**UNION TOWNSHIP BOARD OF TRUSTEES  
JULY 8<sup>TH</sup>, 2025 MEETING**

**PLANNED DEVELOPMENT  
MAJOR AMENDMENT**

**TONY GIUFFRE, Applicant  
Clepper Lane & Gleneste-Withamsville Road**

***Staff Report: CASE # 13-90-Z***

# PLANNED DEVELOPMENT PLAN

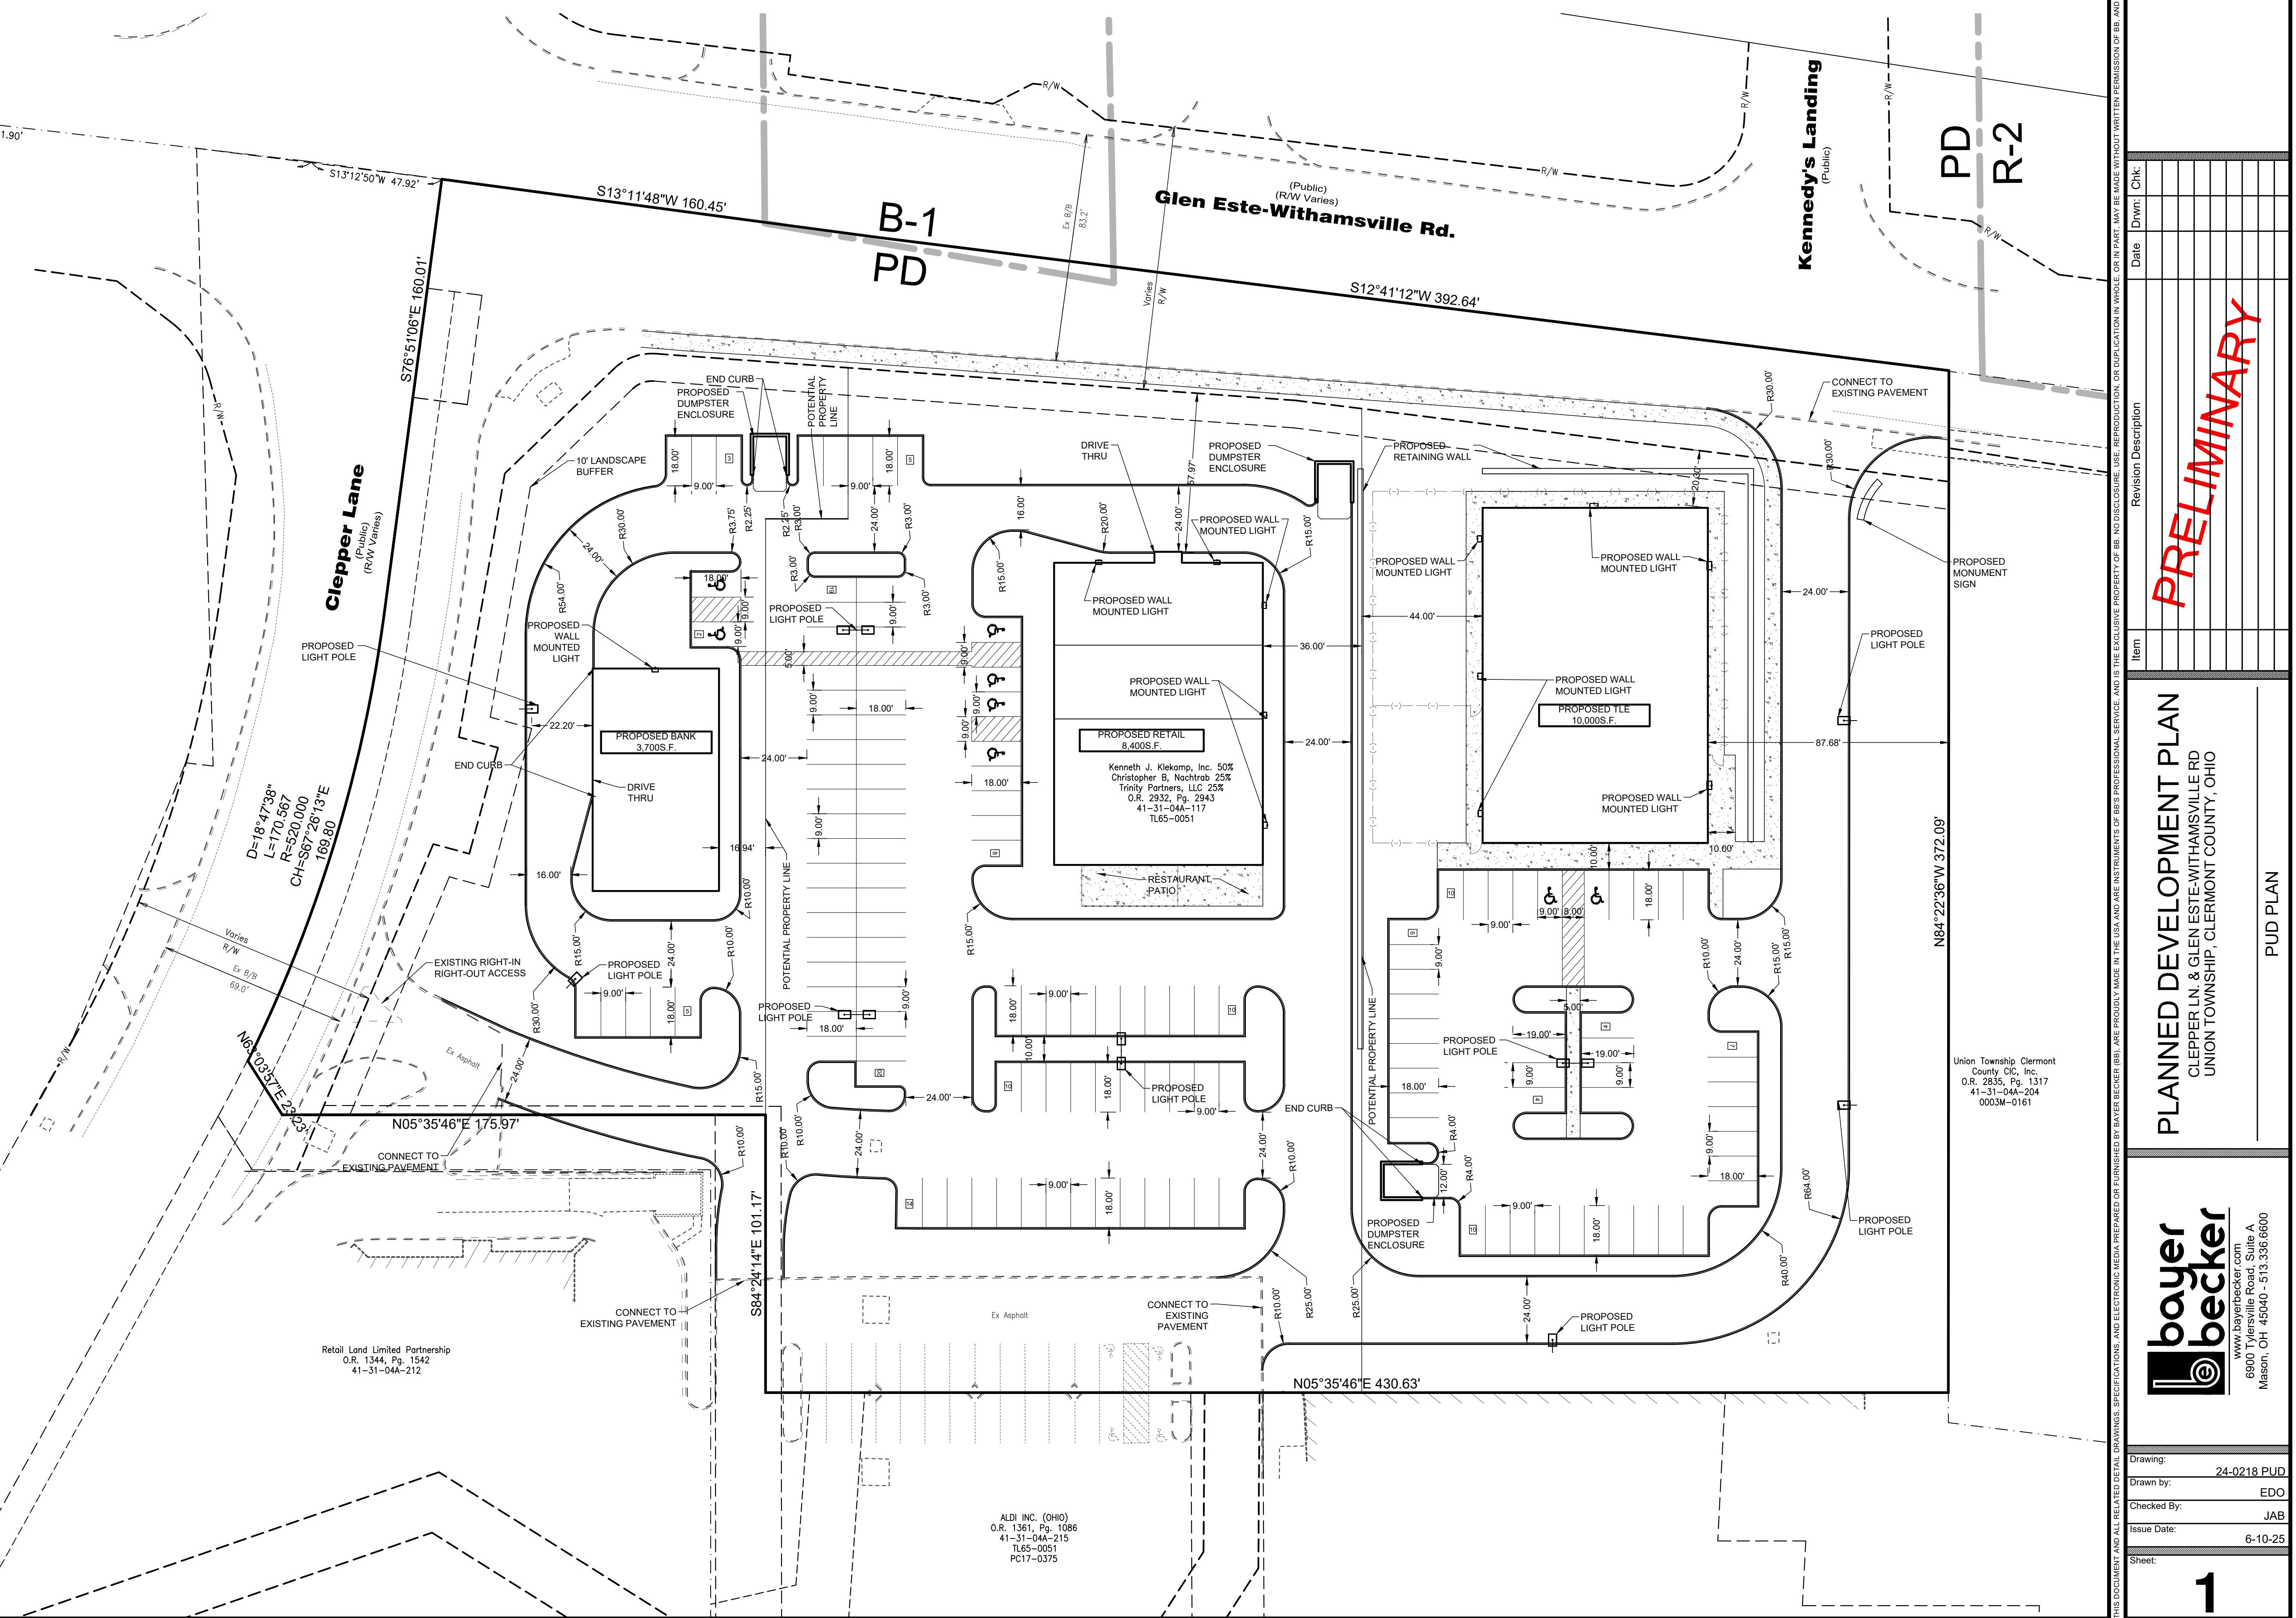
In terms of access to the site, four (4) access-points are currently proposed. The northern access from Clepper Lane to the site is an existing right-in/right-out (only) access, to the east of Steak 'n Shake. The proposed, new primary access intended to serve the site would be from Gleneste-Withamsville Road, directly across from Kennedy's Landing. This access point, *which would require approval from the County Engineer's Office*, is intended to be a shared access point that would serve both this site and the future development site to the south (currently owned by the Union Township, Clermont County CIC, Inc.). *This is an item that needs to be addressed with a cross-access easement agreement.* The two (2) other access points are designed to tie into the existing parking and internal driveway areas serving Aldi, Steak'n Shake, and Sams Club. Finally, in terms of pedestrian and / or multi-modal access to the site, a sidewalk is proposed along Gleneste-Withamsville Road, however, no sidewalk appears to be proposed along Clepper Lane on the current plans. *Per the Horizon 2030: Union Township Comprehensive Land Use Plan a sidewalk is required along Clepper Lane (as well as Glenete Withamsville Road).*

*Although a landscaping plan has been submitted, the current plan is lacking detailed information (to accurately reflect the plant types and sizes)—and would need to be enhanced in the areas adjacent to the proposed dumpsters as well as along the frontage / road right-of-way areas of the site (which should include street trees). Additional details with respect to proposed retaining walls would also be needed as part of a subsequent commercial zoning permit review.*

The current development plans indicate that two (2) of the three (3) proposed dumpsters are intended to be located along public street frontage (Gleneste-Withamsville Road)—which would be in direct contradiction to the Land Use Plan, and would counteract *Corridor's stated objective of having "...development oriented to foster strong streetscape impressions."* Therefore, staff finds that the two (2) dumpsters currently shown along the road rights-of-way / frontage would need to be moved to the interior development area(s).

- 2) The Applicant must acknowledge on all plans that the Gleneste Withamsville primary access for the site is intended to be a shared access point that would serve both this site and the future development site to the south. *This is an item that must be addressed with a cross-access easement agreement.*

- 3) The Applicant would need to install a 6-foot sidewalk along the both Clepper Lane and Gleneste-Withamsville Road rights-of-way around the perimeter of the northern and eastern property boundary. *This is an item that could be addressed administratively by staff.*

- 6) The Applicant would need to provide a more detailed, enhanced landscaping plan—to accurately reflect the plant types and sizes, enhance plantings in the areas adjacent to the proposed dumpsters, and to provide street trees and plantings along the frontage / road right-of-way areas of the site. Details with respect to proposed retaining walls would also be needed. *This is an item that could be addressed administratively by staff.*

- 9) Staff finds that the two (2) dumpsters currently shown along the road rights-of-way / frontage would need to be moved to acceptable interior development area(s), with adequate vegetative buffering and appropriate brick and / or masonry dumpster enclosures. *This is an item that could be addressed administratively by staff.*

LIGHTING SITE PLAN	SCALE 1"=30'-0"	DESIGNER JJ	CHECKED JJ	DATE 05/27/25	SHEET S1
--------------------	-----------------	-------------	------------	---------------	----------

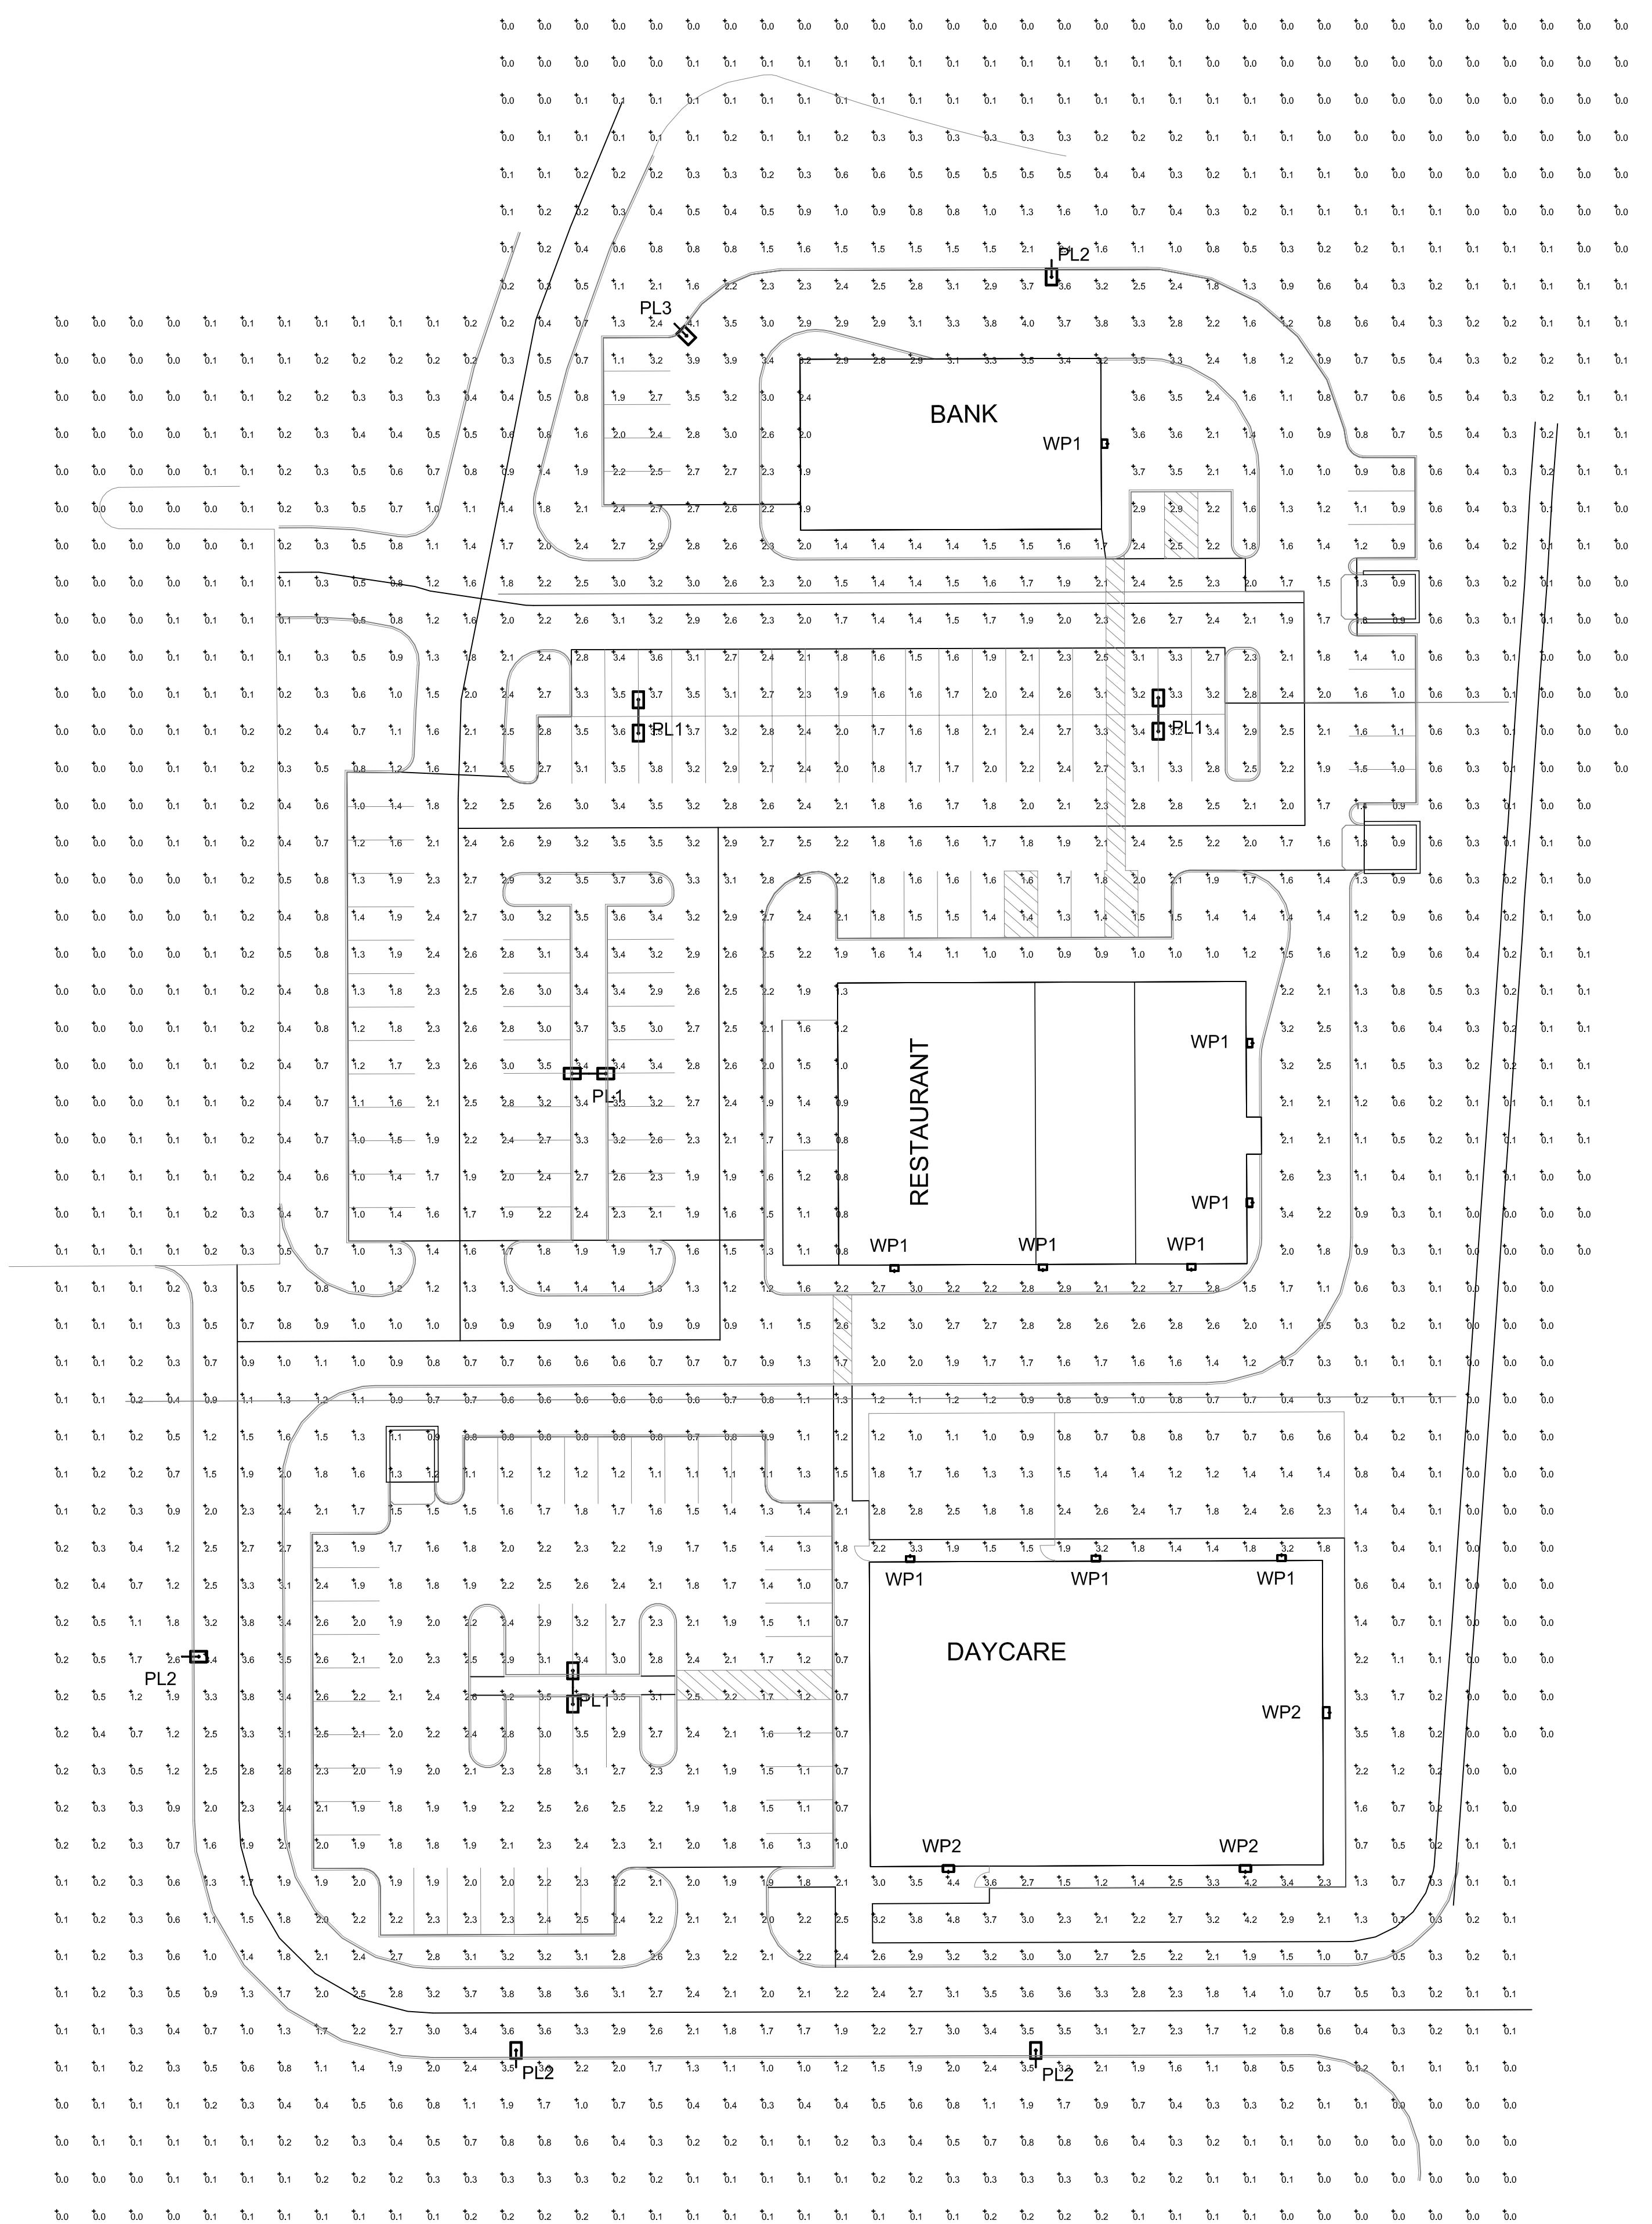
A lighting/photometric plan has been provided. Most of the plan meets the Township's requirements with respect to proposed foot-candle measurements; however, there are some areas in the southern and southwestern portion of the property where the plan would need to be revised. Additionally, details and spec sheets with respect to all proposed lighting would need to be submitted.

- 8) A lighting / photometric plan for the proposed site has been submitted. All lighting would need to be noted as “inward or downward directed and shielded, dark-sky compliant” and of sufficient intensity to illuminate without projecting onto the adjoining residential property (i.e. less than or equal to 1.0-foot candle at the property lines and road rights-of-way). Additionally, a 1.0-foot candle measurement along the proposed property boundaries (if a parcel split is to occur) would need to be addressed properly. \*Details / specs of proposed lighting must be provided; however, *this is an item that can be addressed administratively by staff.*
